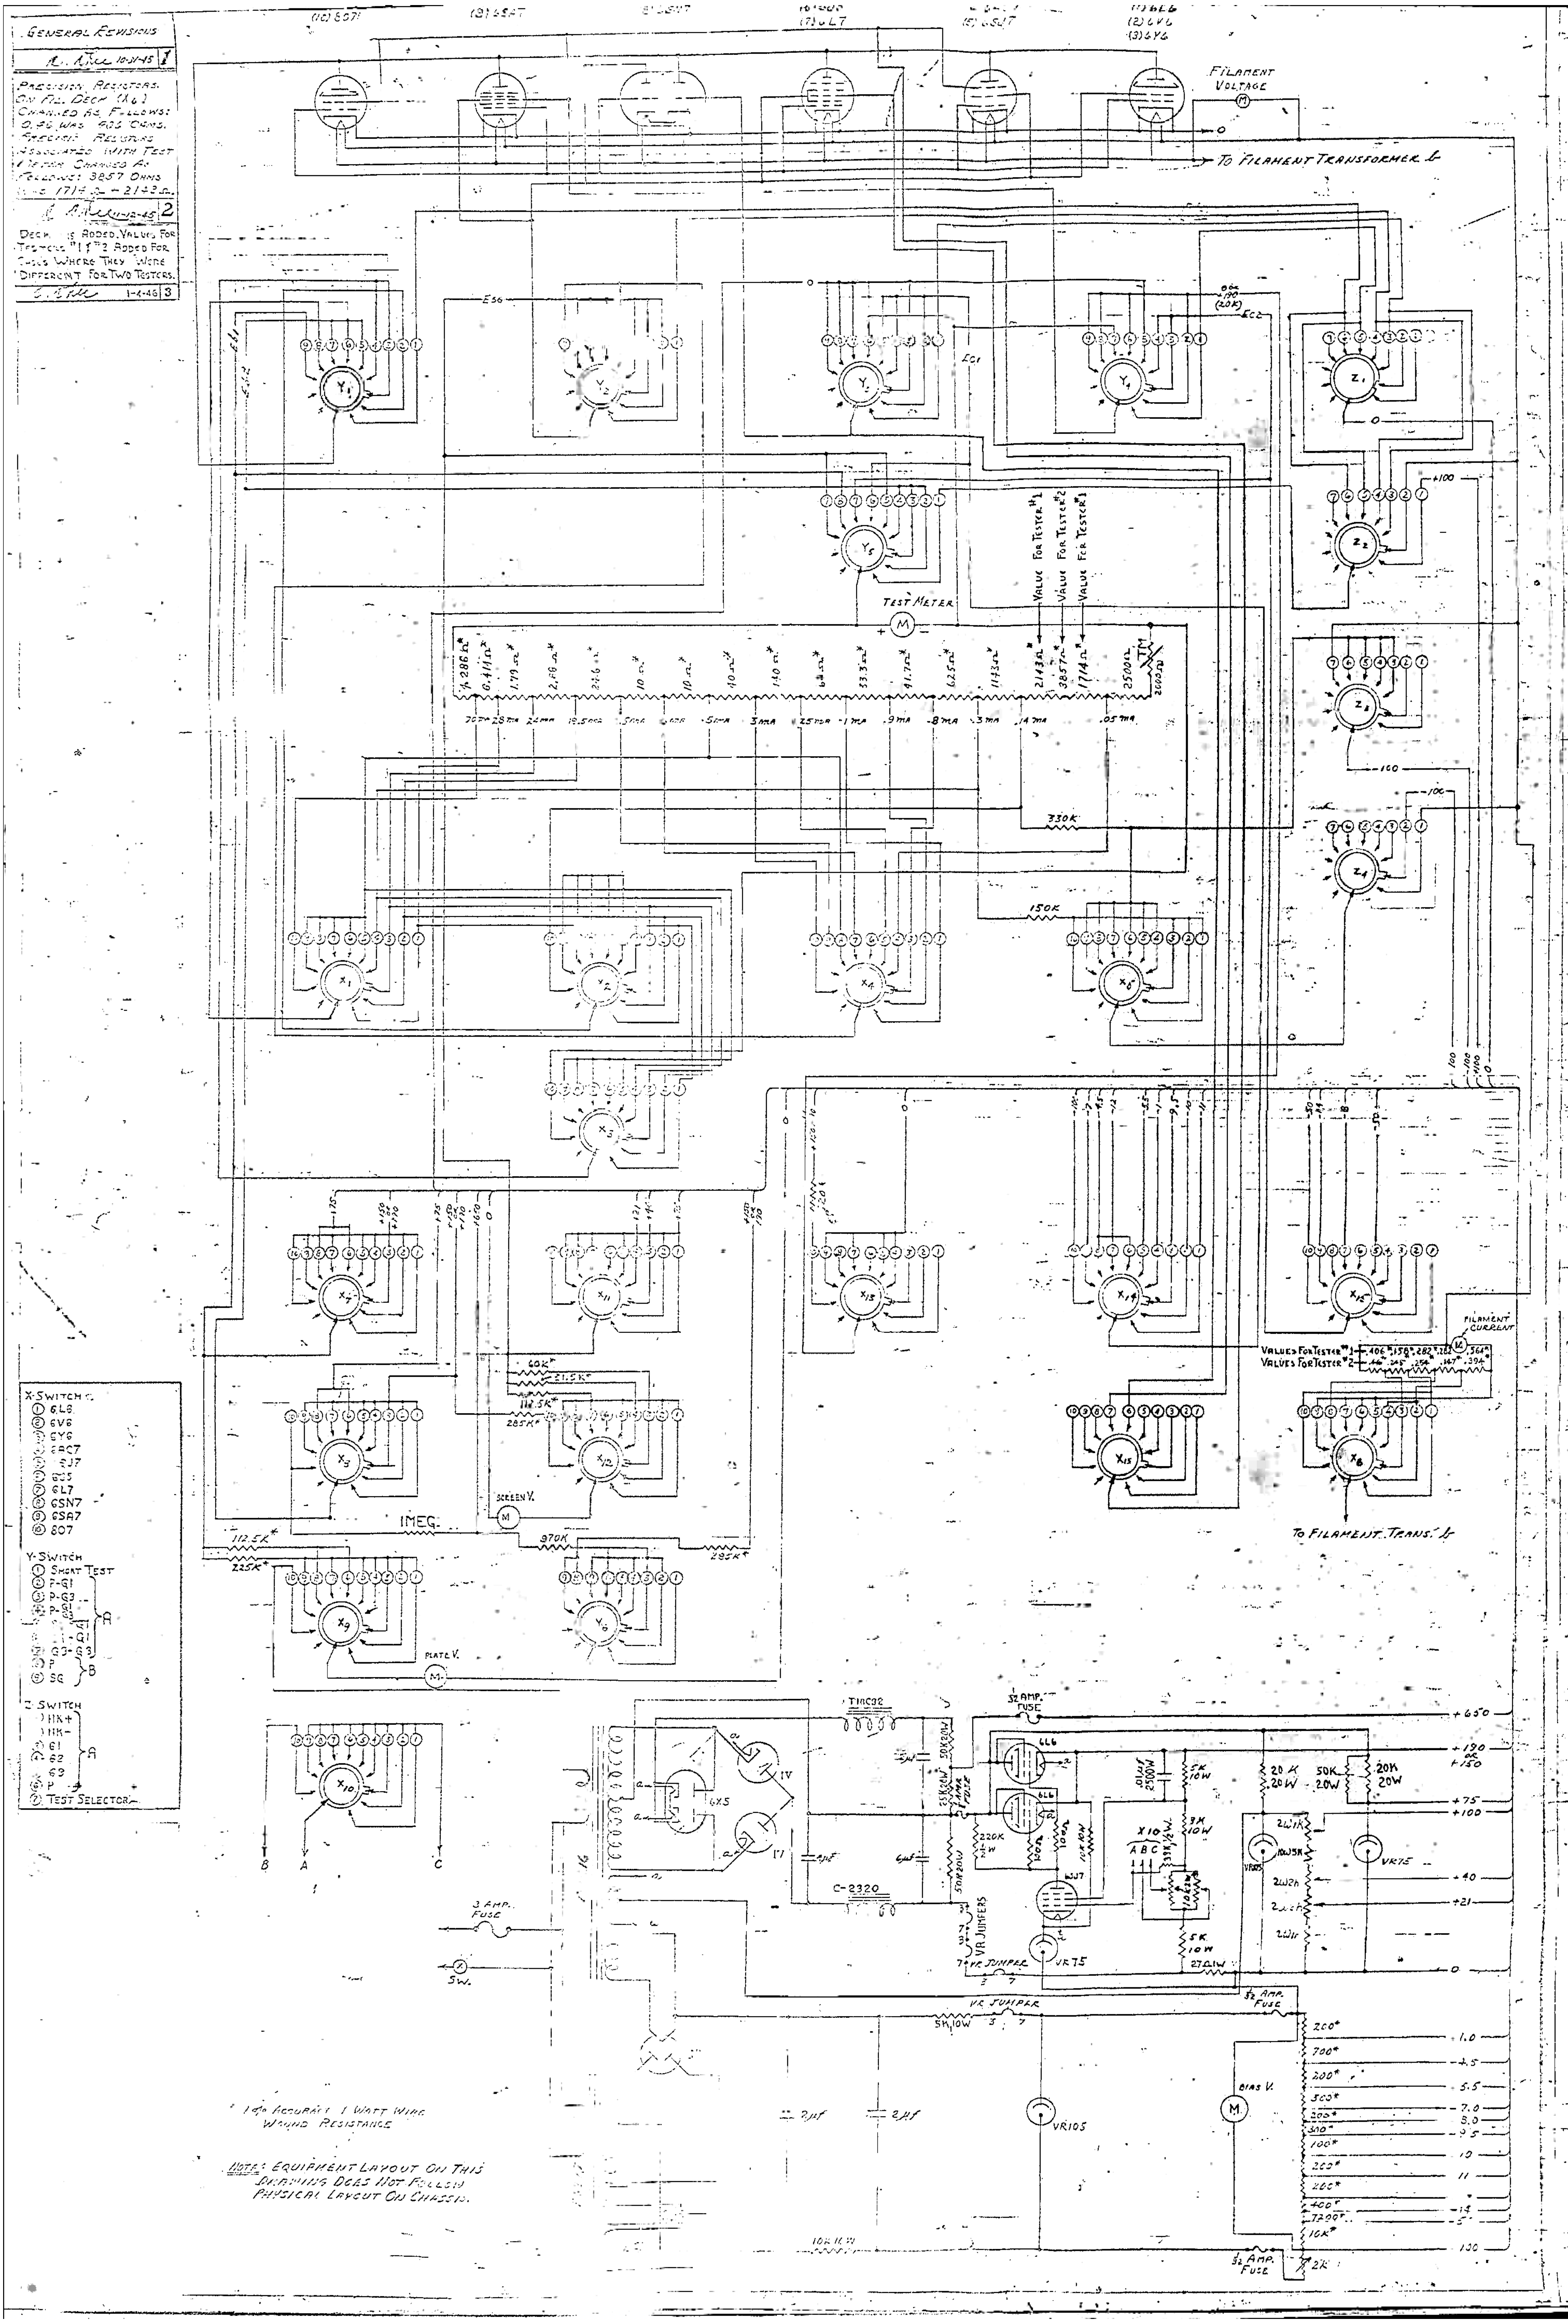
GENERAL REVISIONS
10-31-45 1
PRECISION RESISTORS ON FIL. DECK (X6) CHANGED AS FOLLOWS: 0.46 WAS 405 OHMS. PRECISION RESISTORS ASSOCIATED WITH TEST METER CHANGED AS FOLLOWS: 3857 OHMS 1714 Ω - 2143 Ω.
2
DECK IS ADDED. VALUES FOR TESTERS #1 & #2 ADDED FOR CASES WHERE THEY WERE DIFFERENT FOR TWO TESTERS.
1-4-46 3
FILAMENT VOLTAGE
TO FILAMENT TRANSFORMER
TEST METER
VALUE FOR TESTER #1
VALUE FOR TESTER #2
VALUE FOR TESTER #3
FILAMENT CURRENT
VALUES FOR TESTER #1
VALUES FOR TESTER #2
TO FILAMENT TRANS.
SCREEN V.
PLATE V.
BIAS V.
1MEG.
X-SWITCH
① 6L6
② 6V6
⑦ 6L7
⑧ 6SN7
⑨ 6SA7
⑩ 807
Y-SWITCH
① SHORT TEST
② P-G1
③ P-G3
⑨ SG
Z-SWITCH
HK+
HK-
⑥ P
⑦ TEST SELECTOR
3 AMP. FUSE
SW.
VR JUMPERS
VR JUMPER
C-2320
VR75
VR105
* 1% ACCURATE 1 WATT WIRE WOUND RESISTANCE
NOTE: EQUIPMENT LAYOUT ON THIS DRAWING DOES NOT FOLLOW PHYSICAL LAYOUT ON CHASSIS.
